RESPONSE TO REQUEST FOR ADDITIONAL INFORMATION

APR1400 Design Certification

Docket No. 52-046

RAI No.: 154-8064
SRP Section: 16 - Technical Specification
Application Section: 16 - Technical Specification
Date of RAI Issue: 08/17/2015

16.1.2.4 Combined License Information

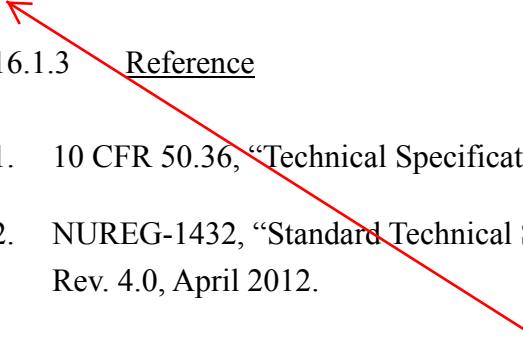
Regarding generic TS and Bases references to the APR1400 DCD, COL plant-specific TS and Bases will need to change DCD to FSAR, or add FSAR to references to the FSAR, following COL issuance by way of (1) the license amendment process, as we have seen with the Vogtle Units 3 and 4, and Summer Units 2 and 3; or (2) the generic TS exemption process, as we have seen with the South Texas Project (STP) Units 3 and 4 COL application. Staff concludes that it is more efficient to use "FSAR" instead of "DCD" in generic TS and Bases, thus avoiding having to process an exemption during the COL application review, or a license amendment after COL issuance to change DCD to FSAR. Accordingly, the applicant is requested to replace all DCD Tier 2 references in the proposed generic TS and Bases to FSAR references, and add FSAR to DCD references that do not include the modifier DCD or DCD Tier 2. Staff also suggests revising DCD Tier 2 Section 16.1.2.4 Combined License Information, with a statement to explain that in the generic TS and Bases, FSAR means DCD Tier 2.

To enable the licensing process for the Combined License (COL) application or a subsequent license amendment after a COL issuance, KHNP will replace all DCD Tier 2 references in generic Technical Specifications and Bases to FSAR references in Revision 1 of the DCD. Also, the text of DCD Tier 2 Section 16.1.2.4 Combined License Information will be revised as shown in attached markup.

DCD 16.1.2.4 will be revised as shown in attached markup.

The references in generic TS and Based include FSAR. FSAR will be available in COL step. The main reason of it is to avoid having to process an exemption during the COL application review, or a license amendment after COL issuance to change DCD to FSAR.
